**ADDENDUM
NO. 1**

March 3, 2021

Scott County School District 1 – Austin Elementary Additions & Renovations and HS Pool Renovation
Austin, IN 47102

ADDENDUM NO. ONE

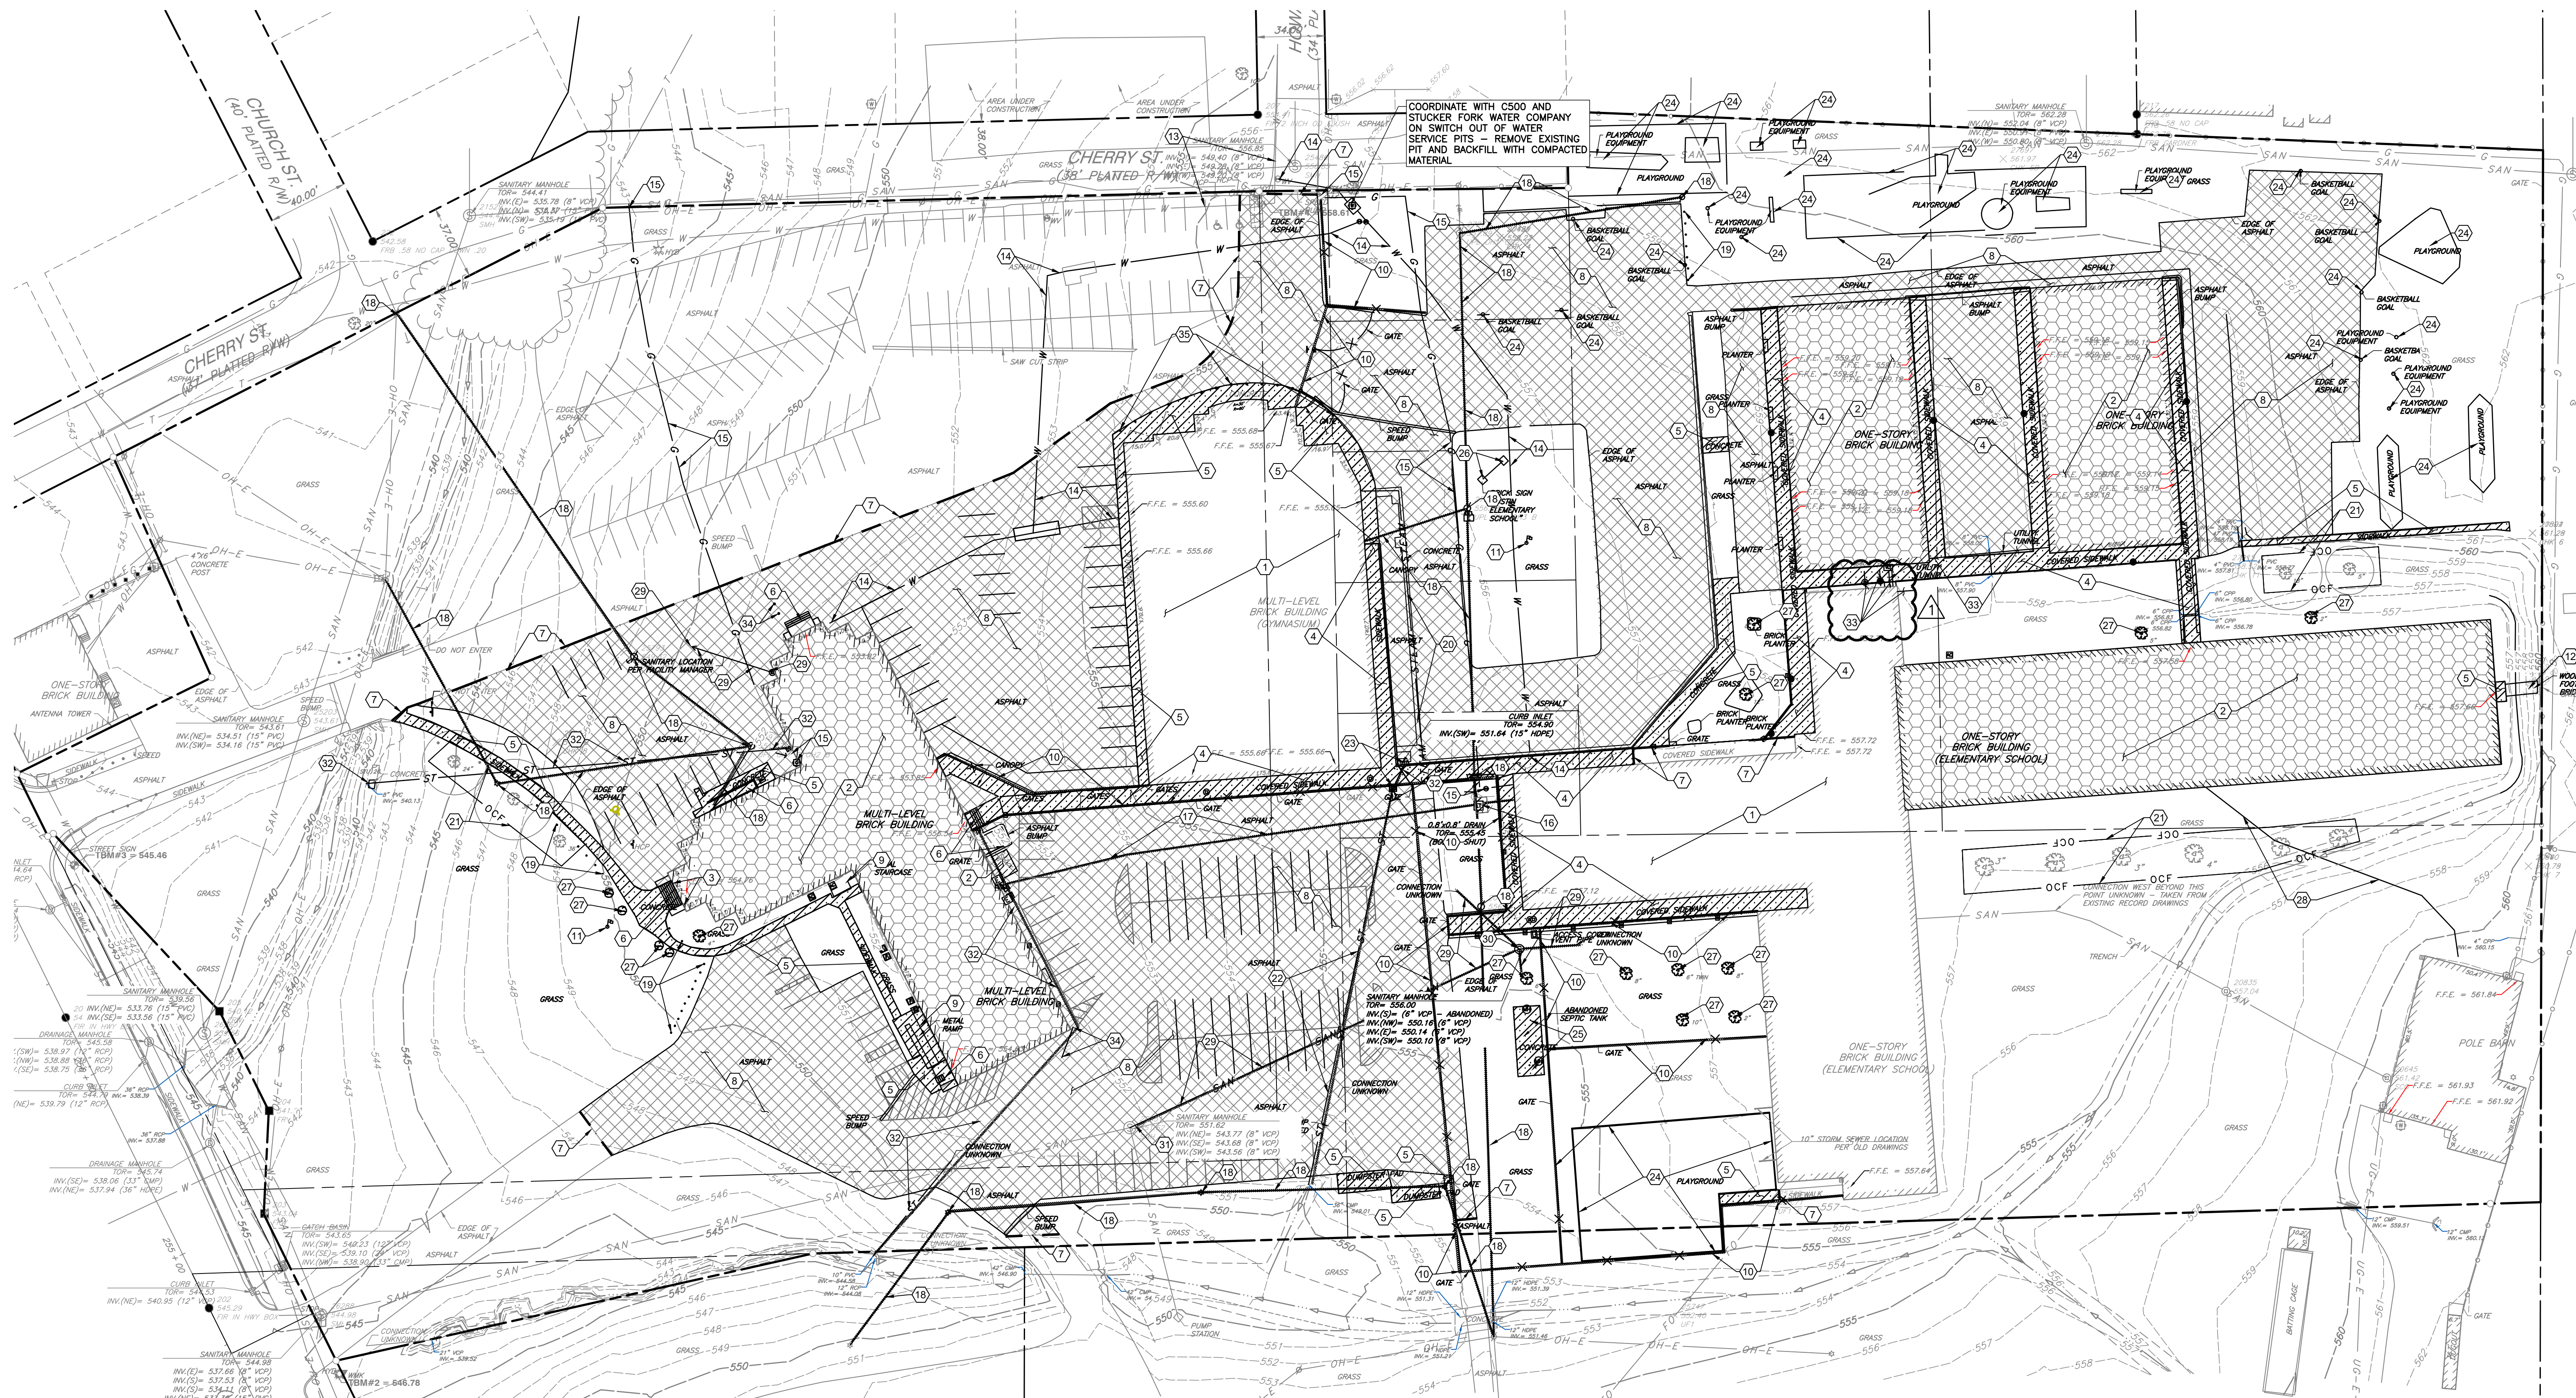
Refer to drawing for revised plan note 33 on utilities and utility tunnel on North East corner of portion of building to remain.
